# Land South of (East of Griffin Place) Radwinter Road, Saffron Walden

Appeal Reference: APP/C1570/W/22/3296426

Technical Note- Review of Responses to  
Follow-Up Consultation for Highways  
Proposals at Junction 4

August 2022

**Figure 1: Distribution of Development Traffic Travelling North-West from Appeal Site**

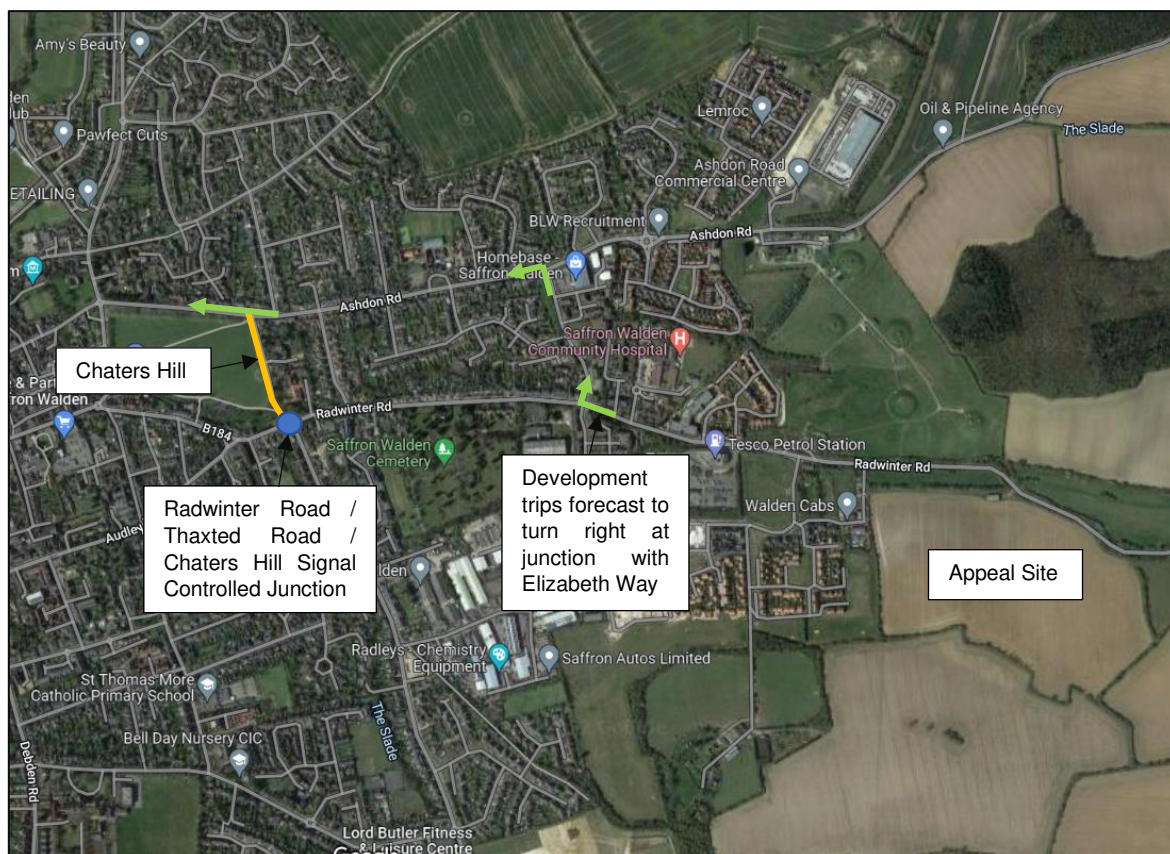
- 2.12 It is suggested in the Response from the Rule 6 Party that there is already evidence that the existing brick work on the bridge has been damaged by vehicles. It is then further suggested that additional damage would occur due to the *“increase in traffic”*.

- 2.16 The development is not forecast to increase traffic flows on Chaters Hill. Chaters Hill runs one-way northbound from the junction with Radwinter Road and Thaxted Road to Ashdon Road. The distribution of development trips agreed with ECC is vehicles from the development travelling on Ashdon Road to the west of Chaters Hill will turn right at the junction of Radwinter Road with Elizabeth Way and then turn onto Ashdon Road from Elizabeth Way to travel westbound on Ashdon Road. This is shown in **Figure 1** below. The location of the Appeal Site and Chaters Hill are also shown for context.

- 2.17 It is clear from Figure 1 that vehicles travelling westbound on Ashdon Road will turn right at the first available opportunity via Elizabeth Way, rather than continuing on Radwinter Road to the junction with Thaxted Road. It should be noted that development traffic seeking to travel south-west will travel through the Radwinter Road / Thaxted Road junction. The distribution of development traffic is agreed with ECC.
- 2.18 On this basis there will be no increase in traffic at the Chaters Hill bridge as is suggested in the Response from the Rule 6 Party.
